MONTGOMERY COUNTY HISTORIC PRESERVATION COMMISSION STAFF REPORT

Address: 7105 Poplar Avenue, Takoma Park Meeting Date: 7/15/2020

Case Number: 37/03-20YREVISION Staff: Dan Bruechert

PROPOSAL: Tree removal and site wall construction

Here is the existing wall.

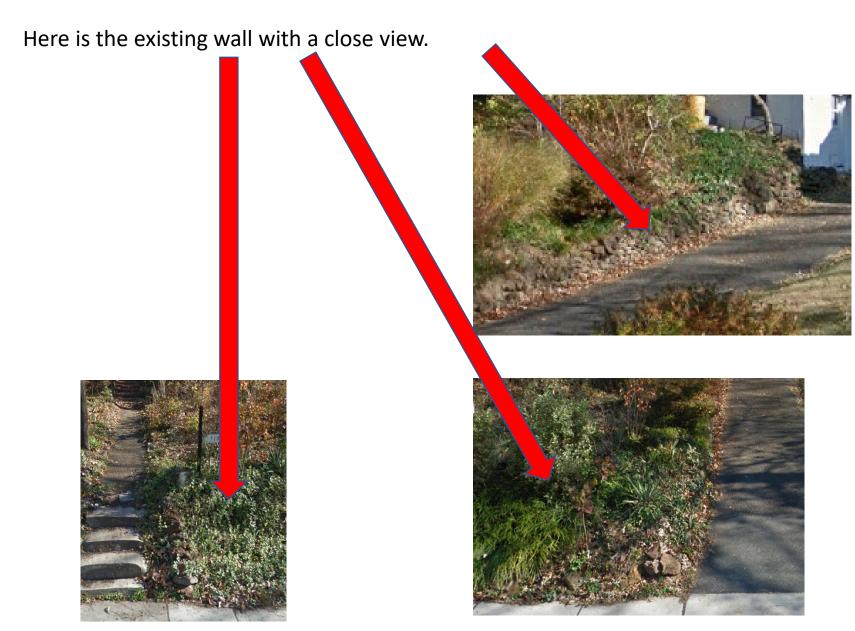
The existing site wall is constructed out of stone rubble and is overgrown with vegetation and has substantially degraded. The applicant proposes to remove the existing stone and install a new textured concrete block (specs attached) wall in its place. The height of the new wall will match the existing.

Staff finds that the existing wall has failed and needs to be removed. The mortar is gone, the wall has been taken down in select locations, and it is largely overgrown with ground cover. Staff recommends the HPC approve removing the existing wall.

In order to maintain the existing grade on the site, the applicant proposes installing a new concrete block wall that will match the approximate height of the existing. Staff finds that the height of the proposed wall is appropriate for the site, as it matches a historic feature. Staff additionally finds that the proposed concrete block is an appropriate material. Staff finds the rough texture and mottled color of the block is in keeping with the visual character of natural stone. Staff additionally finds the proposed concrete block is consistent with the wide variety of materials used for site walls on this block (which includes parged

concrete, brick, natural stone, and concrete block) and throughout the Takoma Park Historic District. Staff recommends approval of the proposed retaining wall.

The retaining wall will be replaced with concrete retaining wall concrete block on the side and front of the house.

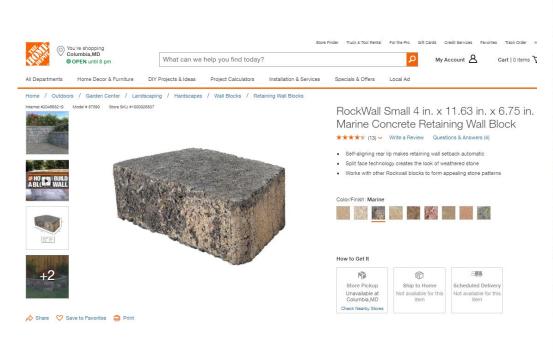
We will replace the wall with the bricks below and it will be a similar look to the picture except it will border the driveway and sidewalk in the same height and width as we have it today.
